Re: Supplemental Information for Badgerjack Resource Holdings Permit Applications –
Responses to Questions/Comments from District Consultants

Thornhill Group, Inc. (TGI) received from you on June 6, 2023 the e-mailed transmittal of questions and comments from Ground Water Consultants (GWC) and Advanced Groundwater Solutions (AGS) regarding the Badgerjack Resource Holdings, L.P. Aquifer Evaluation Report that TGI prepared and is dated February 10, 2023. This letter provides our responses to those questions and comments.

Revised Figure 2:
BVGCD Wells Within 1 Mile

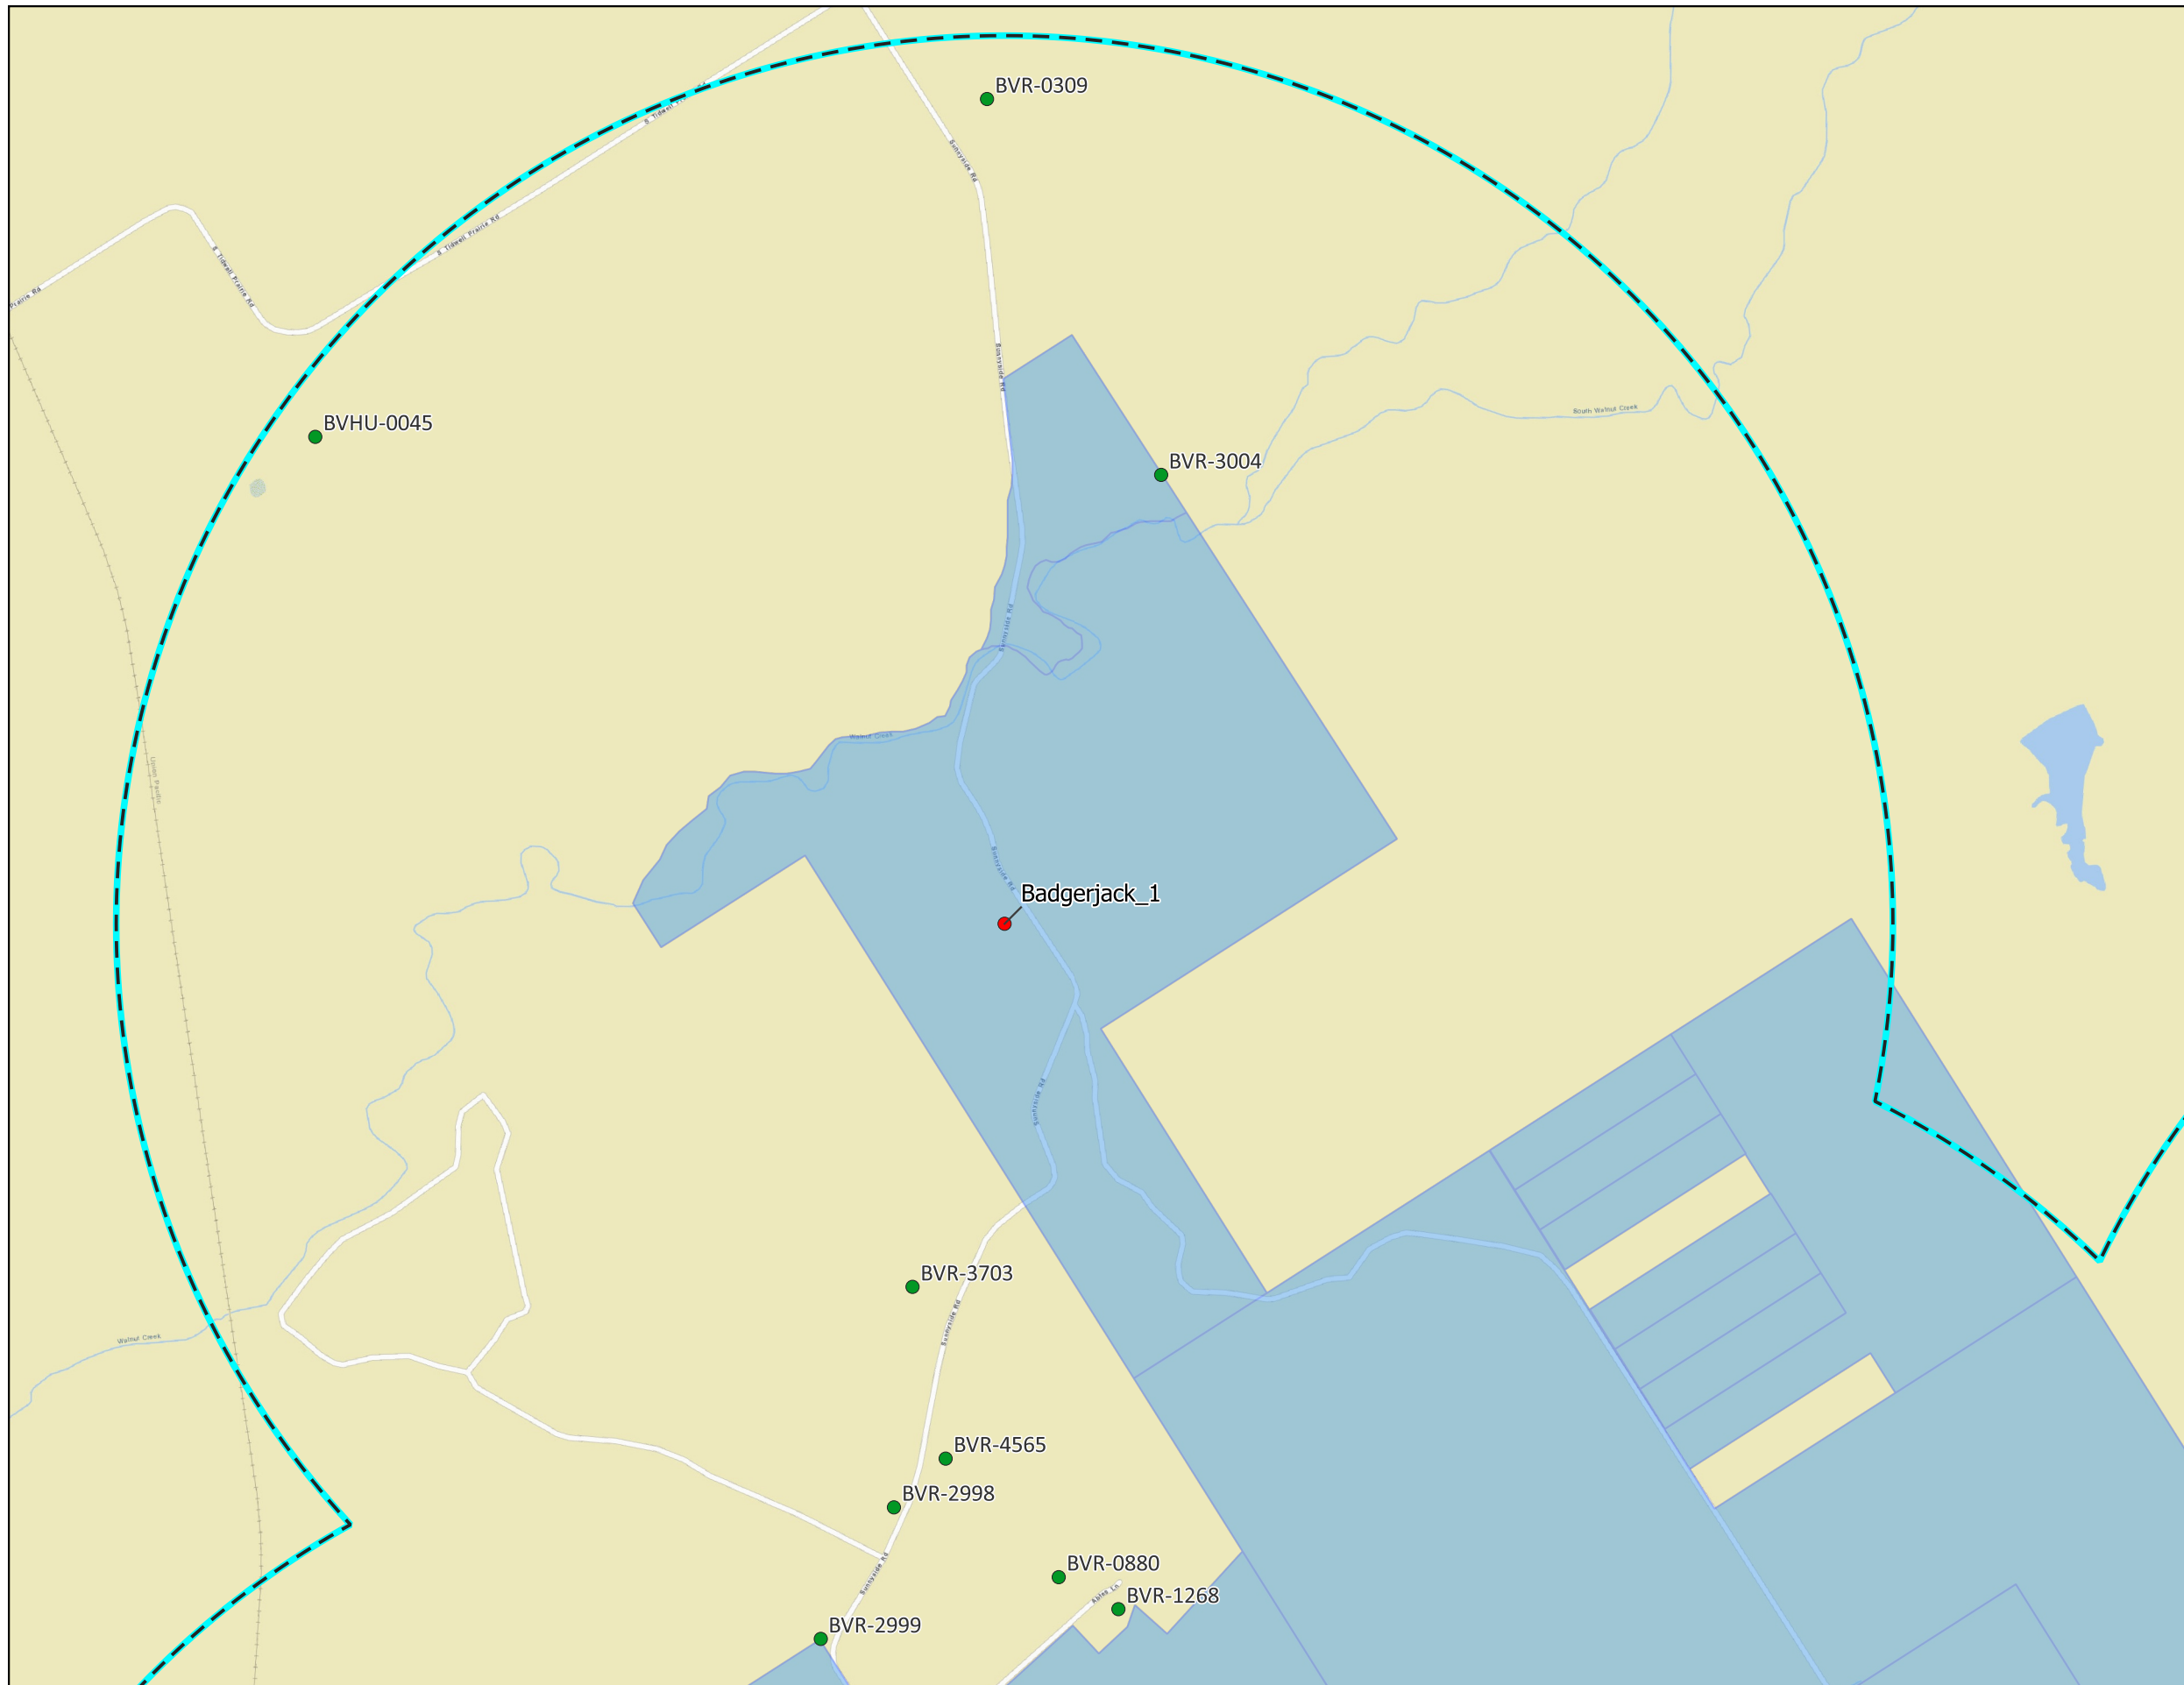
- 1. The number of BVGCD permitted and registered wells within 1-mile of the proposed Badgerjack wells shown on Figure 2 of the Hydrogeological Report is not the same as the number of BVGCD Simsboro wells shown on Exhibit No. 1 (Figure No. – Map depicting Locations of Badgerjack Wells Nos. 1, 2, 3, 4 & 12) included in the Badgerjack Resource Holdings, LP Application submitted to BVGCD. Table 2 included [sic] the Hydrogeological Report has the same number of wells as shown of Figure 2 included [sic] the Hydrogeological Report but does not include the additional wells shown on Figure 2 included as Exhibit No. 1. Please check the BVGCD permitted and registered Simsboro wells within 1-mile of the proposed Badgerjack wells and update Table 2 as needed.*

Table 2 has been updated and the missing wells have been added (see Attachment). TGI also includes revised Figure 2 and added Figures 2a through 2c showing BVGCD wells within 1 mile of the proposed Badgerjack well sites.

Revised Figure 7:
1-Year Analytical Drawdown

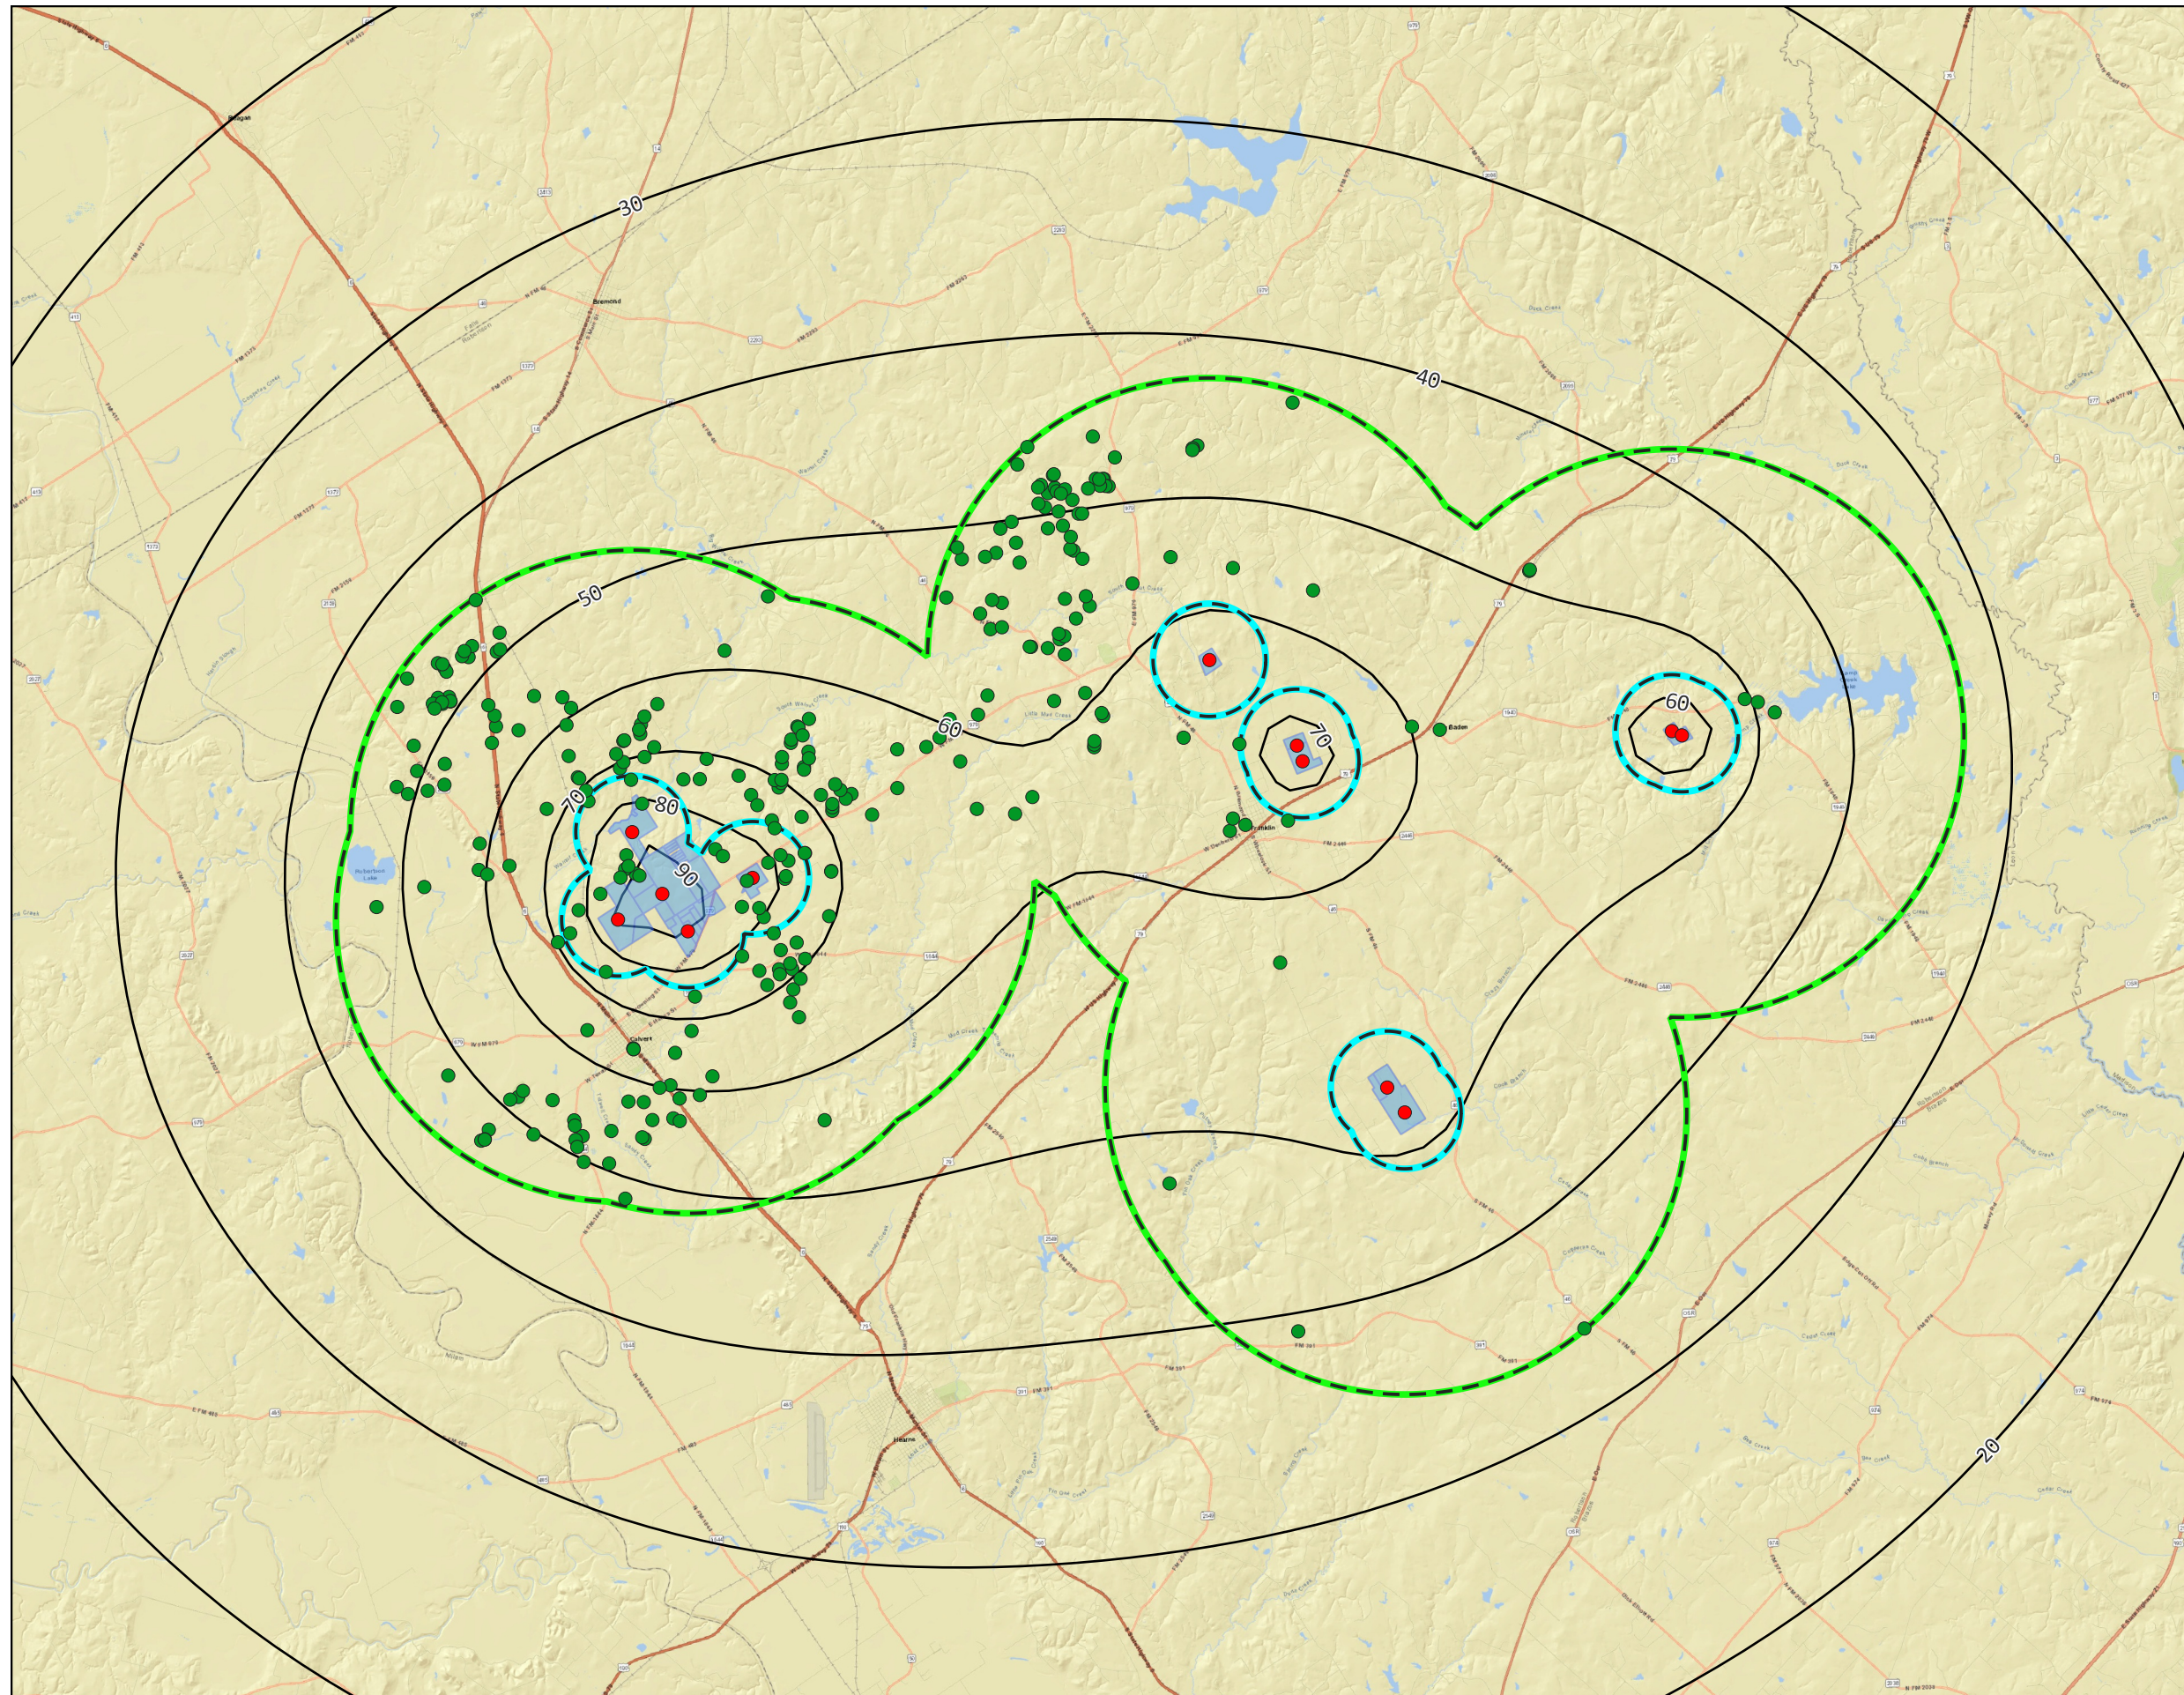
3. *Please check the 1-year and 10-year GAM and analytical modeling results shown in the table on Page 9 of 10 of the TGI Aquifer Evaluation Report. Some drawdown values shown in the table on Page 9 of the TGI report are not in agreement with the contours shown on Figures 5, 6, 7, and 8 in the TGI Aquifer Evaluation Report.*

2. *AGS was able to generally recreate the 1-year and 10-year analytical model results for most of the wells shown on Table 1 of the Aquifer Evaluation Report. However, there are differences between some of the simulated drawdown results at the Badgerjack wells shown in the table on Page 9 of 10 of the TGI Aquifer Evaluation Report and the results obtained during the AGS analytical modeling verification simulations. AGS used the Badgerjack well production rates and aquifer properties outlined in the Aquifer Evaluation Report to estimate drawdown values at 1-foot from the well(s). Please elaborate on the TGI methodology, if different from the above, used to estimate the analytical model results at the Badgerjack wells shown in the table on Page 9 of 10 of the TGI Aquifer Evaluation Report.*

TGI noted discrepancies in the analytical values. We could not replicate Mr. Bluvstein's Theis calculations and noted that several of the well location inputs were in error; therefore, TGI re-constructed the analytical calculations in accordance with the methodology used in our previous reports submitted to BVGCD. We have re-drawn the drawdown maps and corrected the tabulation. Please replace Figure 7 and Figure 8 in the original Aquifer Evaluation Report with Figure 7 (Revised) and Figure 8 (Revised), respectively. Also, please replace the table on Page 9 of 10 of the original Aquifer Evaluation Report with the tabulation below.
